**IN THE DRAWINGS**

REMARKS

FIG. 1

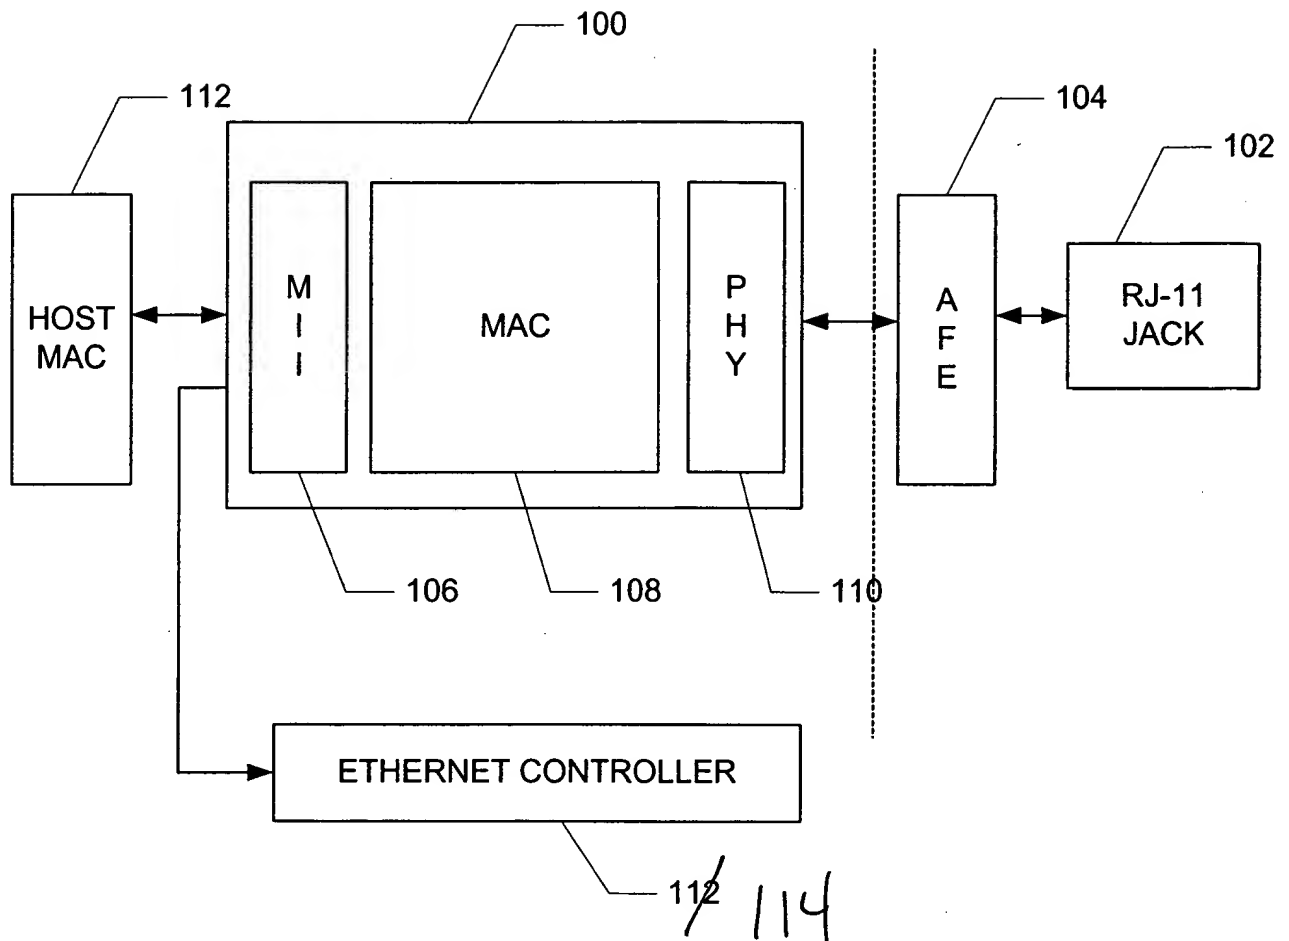
The Examiner has objected to the drawings for not including the reference "LARQ 110" as discussed in Applicants' Specification on page 2, lines 6-7. Paper No. 5, page 2. Applicants amended the Specification, as indicated above, removing the element number "110." Applicants believe the amendment to the Specification addresses the Examiner's objection to the drawings for not including the reference "LARQ 110".

The Examiner has objected to the drawings for including the element "PHY 110" but not including a description of the element in the Specification. Paper No. 5, page 2. Applicants respectfully direct the Examiner's attention to at least page 1, line 19 which discusses Physical Layer (PHY) 110. Accordingly, Applicants believe that the Specification does include a description of the element PHY 110.

The Examiner has further objected to the drawings because reference character "112" has been used to designate both the Host MAC as well as the Ethernet Controller. Paper No. 5, page 3. Applicants have amended Figure 1 to label Ethernet Controller 114 as well as amended the Specification accordingly.

The attached sheet of drawings include changes to Figure 1. This sheet replaces the original sheet of Figure 1. Applicants have added the label of "114" on Figure 1 to identify the element of "Ethernet Controller." Applicants have attached herewith an annotated sheet showing this change to Figure 1 as well as a replacement sheet for Figure 1.
